Re: **Response to Technical Comments**

Chevron Station #9-6991  
2920 Castro Valley Blvd  
Castro Valley, California

Subject: Fuel Leak Case RO0000475, Chevron Station # 9-6991, 2920 Castro Valley Blvd., Castro Valley, CA 94546

FIGURE 1

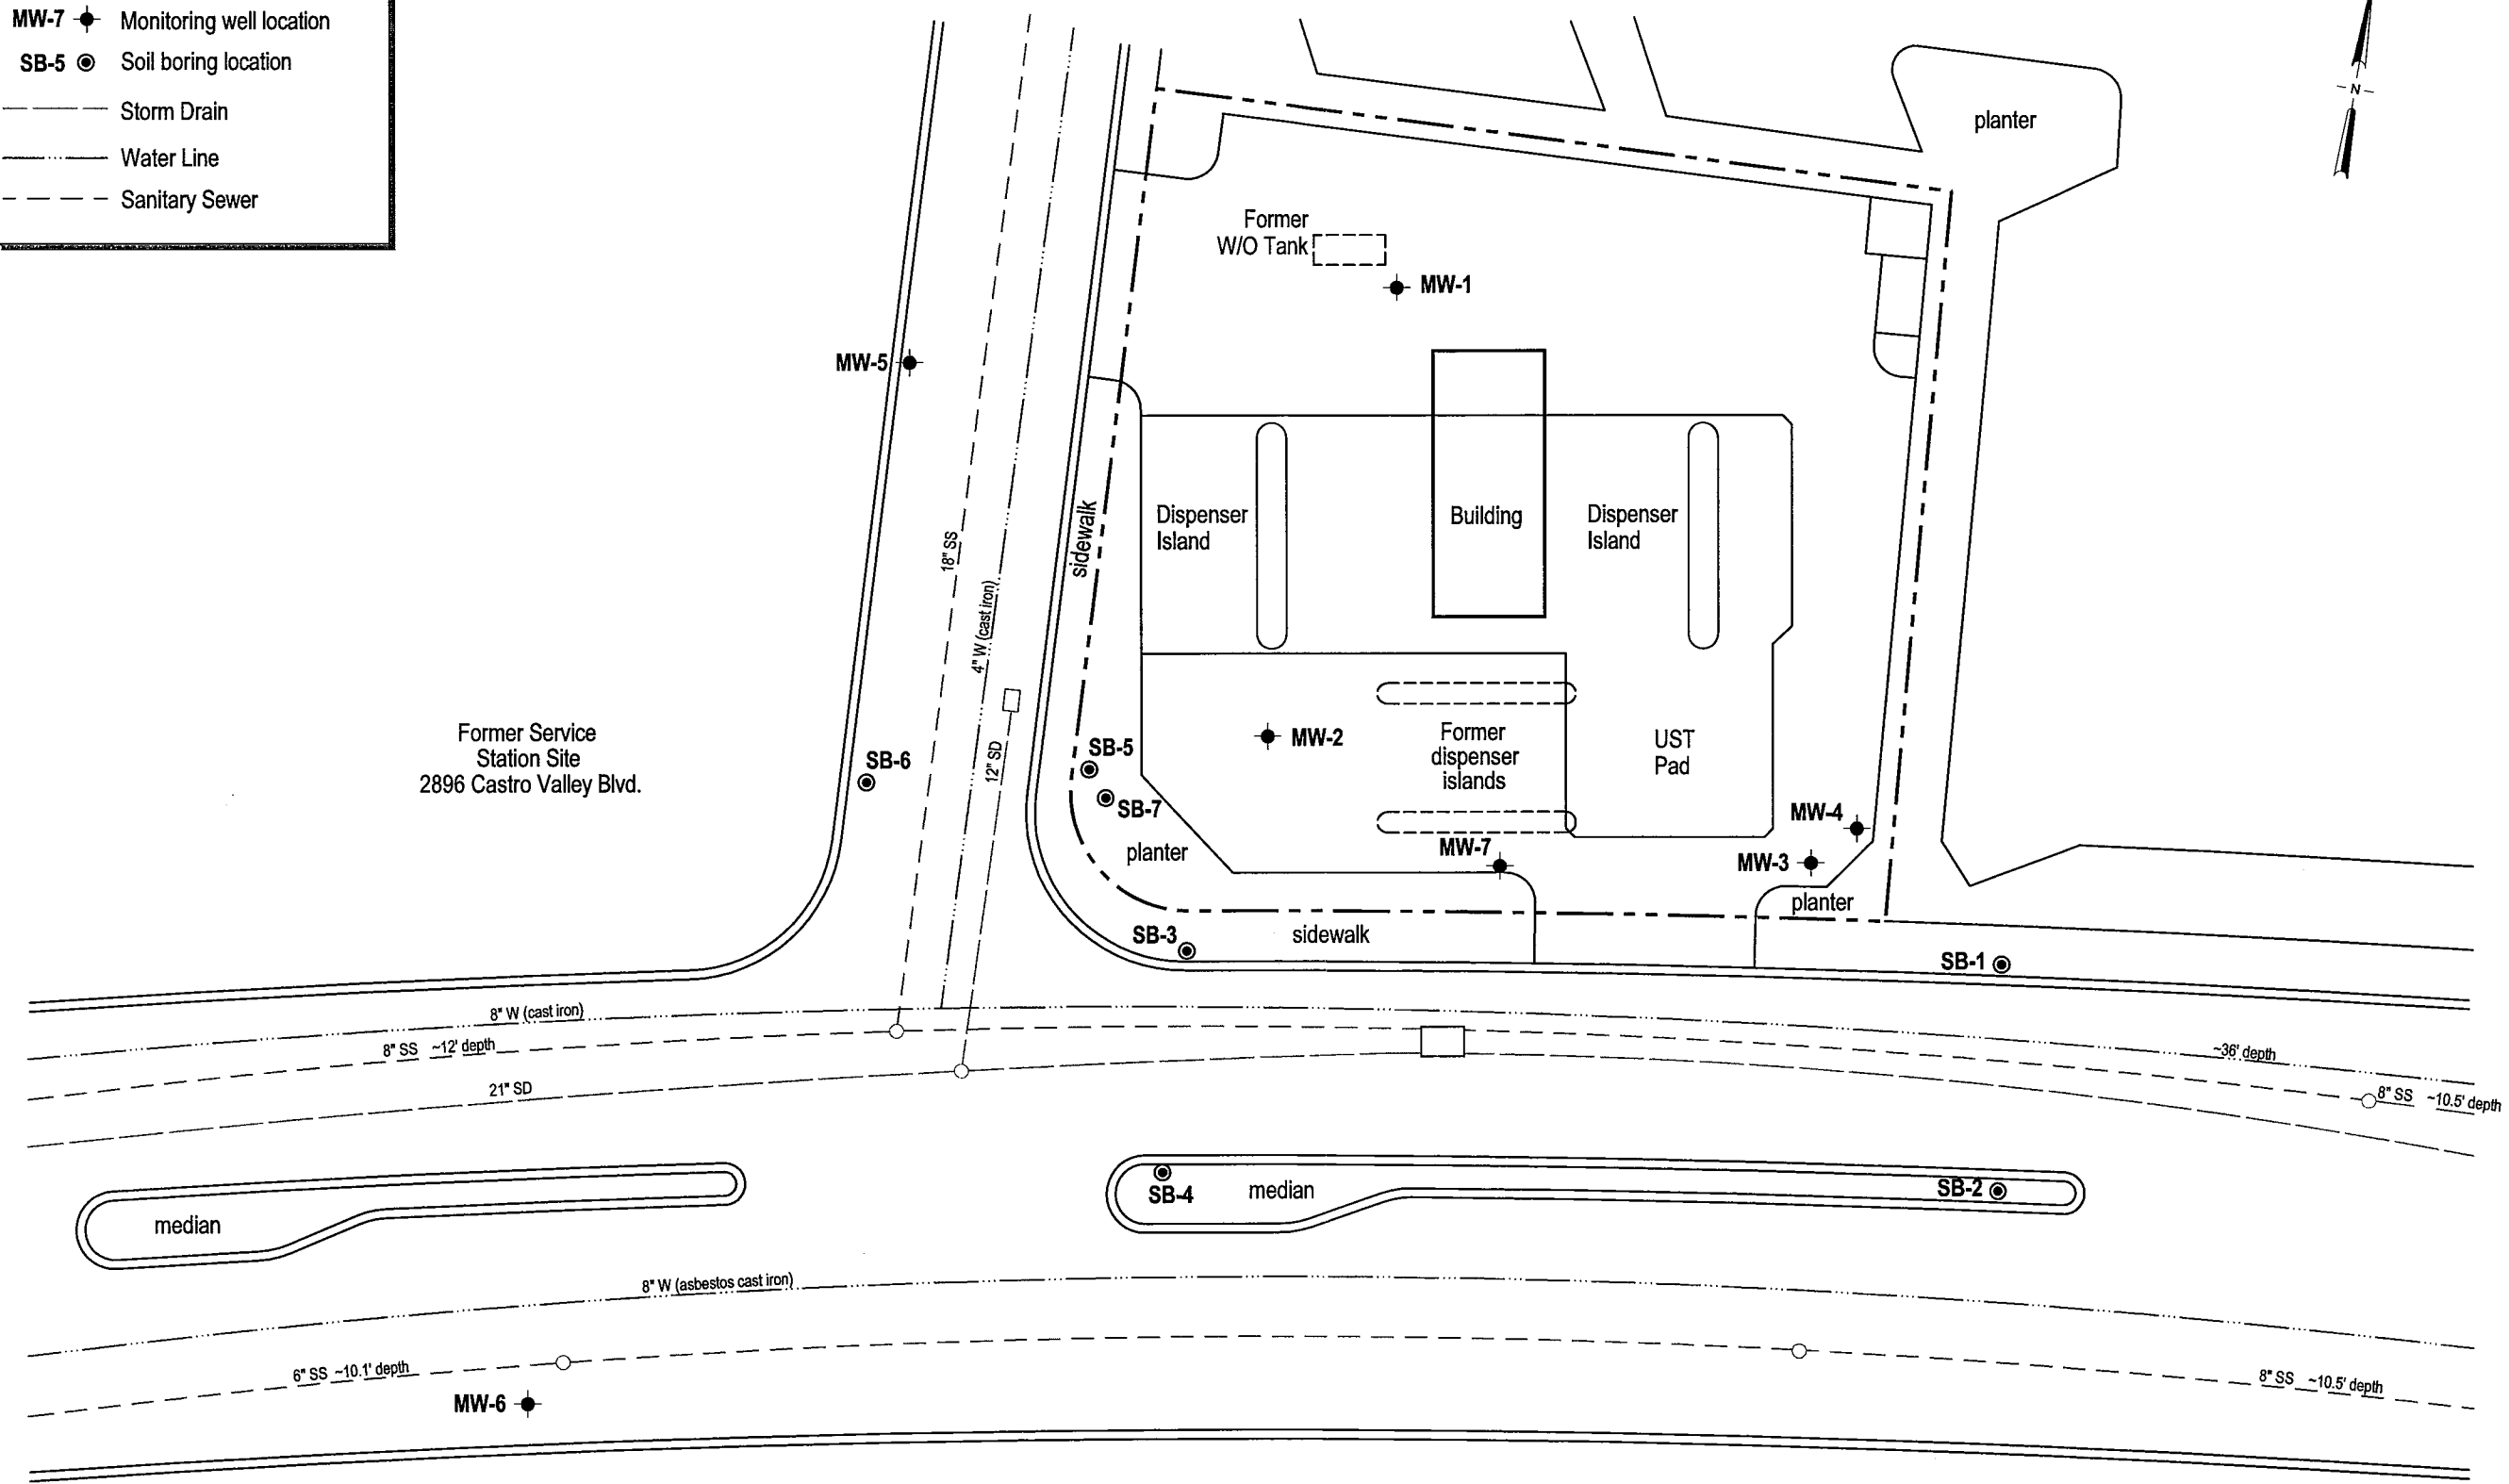
***3. The likelihood of a MTBE release migrating beyond the monitoring well network should be examined. We request you re-evaluate or perform an additional conduit study that details the potential migration pathways and potential conduits (utilities, storm drains, etc.) that may be present in the vicinity of the site. Provide a map showing the location and depth of all utility lines and trenches including sewers and storm drains within and near the plume area. The previous 4/2002 Soil Boring Utility Trench Investigation report results were inconclusive.***

***The conduit study shall also include a detailed well survey of all wells...within a ¼ mile radius of the subject site.***

Utility maps provided in Cambria's recently submitted reports as well as the *Soil Boring Utility Trench Investigation Report* prepared by Gettler-Ryan (G-R) show the approximate locations of all known utility lines and trenching. All depth to lines, where the information is available, has been reported on the maps along with the approximate diameter of the utility lines. Cambria believes these maps provide an adequate representation of current utility lines which should be considered for possible hydrocarbon migration and an additional utility investigation at this time does not appear necessary. Additionally, G-R's report concluded that the utility trenches appeared to be creating a barrier for hydrocarbon migration south and west of the site. G-R further recommended the installation of two monitoring wells near the location of soil boring SB-5 and to the south of the site, across Castro Valley Boulevard to fully define the hydrocarbon plume.

Cambria will prepare geologic cross-sections and isoconcentration maps as part of a SCM to determine the necessity of additional off-site investigation. Additionally, Cambria will perform a Department of Water Resources (DWR) well survey. Results from the well survey will be presented in a tabular form and summarized in the SCM. A site plan depicting utility line depths and diameters are presented as Figure 2.
